## Service Bulletin

## Solutions for movements caused by disinfection liquids on the collimator hand-grips

Copyright © 2021 Agfa NV | Document ID: 74741907

Figure 1: Fine Positioning Controls

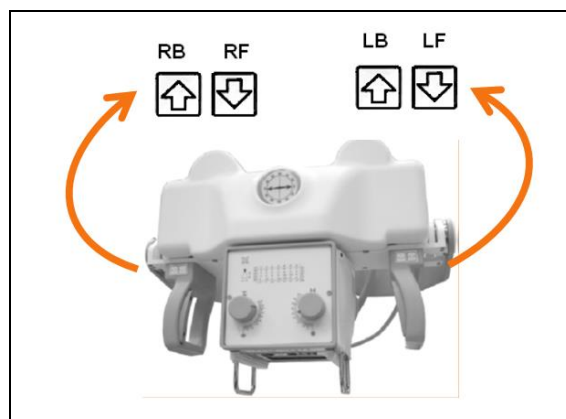
*Cause* When disinfecting by pouring or spraying liquids on the collimator hand-grips, a short-circuit in the fine positioning controls can occur.

These are the four buttons on the hand-grips, which control the (low speed) motion of each driving wheel forwards or backwards:

The system is not able to distinguish a button pressed by a user or a short-circuit.

The result is that the unit moves on its own in a very slow motion and normally in circles as if just one button would be pressed. Note that the motion is at very low speed; the motion control does not allow high speeds for these controls.

A film (sticker) to cover the four buttons as protection against liquid is available:

With DMC firmware version V11R3b8 (or later), an improvement is introduced to stop the mobile unit after 8 seconds. The unit stops regardless of whether the movement has been caused by a mechanical blocked fine positioning button or by a short-circuit. Install DMC firmware version V11R3b9, which is the replacement of V11R3b8 (see section 1.2).
